Norfolk Boreas Offshore Wind Farm Scoping Opinion

SCOPING OPINION

Proposed Norfolk Boreas Offshore Wind Farm

Planning Inspectorate Reference: EN010087

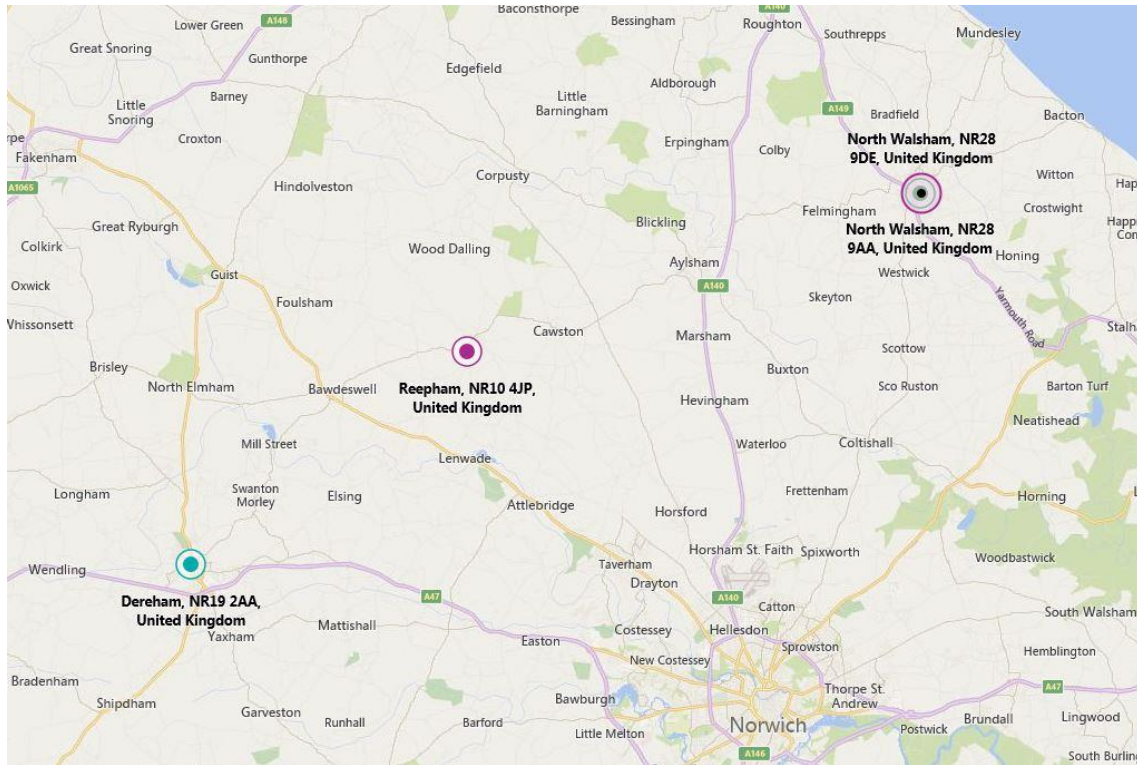
As listed and located on the plan below, Royal Mail has four operational properties that are situated close to the onshore infrastructure scoping area as set out in the Scoping Report.

Royal Mail therefore wishes to ensure the protection of its future ability to provide an efficient mail sorting and delivery service to the public in accordance with its statutory obligations which may potentially be adversely affected by the construction and operation of this proposed scheme.
